**URGENT MEDICAL DEVICE – Correction**

**Reference Number: 8010762-09/06/2023-002-C**

**CARDIOHELP-i Heart Lung Support System**

Figure 1: CARDIOHELP slide rail- exploded view

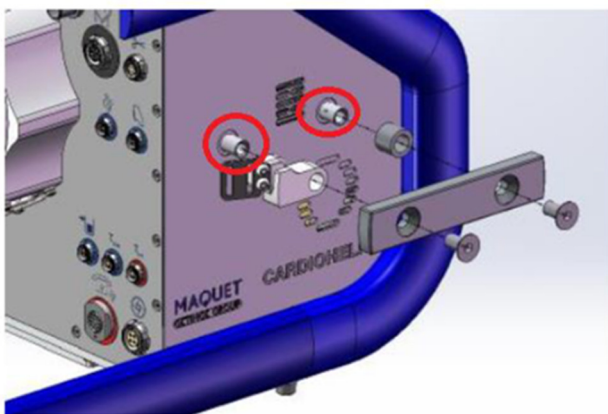
The slide rails are located on the lateral aspects of the CARDIOHELP system. They are attached to the housing of the CARDIOHELP system with the slide rail holder (see red marks in Figure 1). As shown in Figure 2, the slide rail holder consists of a nut bolt welded onto a plate.

The fixation (weld) applied by the supplier to fixate the nut bolt to the slide rail plate was insufficient. The deficient weld allows the nut bolt to break off from the slide rail plate with slight manual force.

- **Please do not fixate any accessory at the slide rail until the slide rail holders have been replaced.**
- **Affected CARDIOHELP-i can be used for intra-hospital transport only when placed on a Sprinter cart.**

A Getinge representative will contact you to arrange for the repair of your CARDIOHELP -i unit(s). Getinge will correct your CARDIOHELP -i unit(s) upon receipt and will return your unit(s) once correction has been completed.
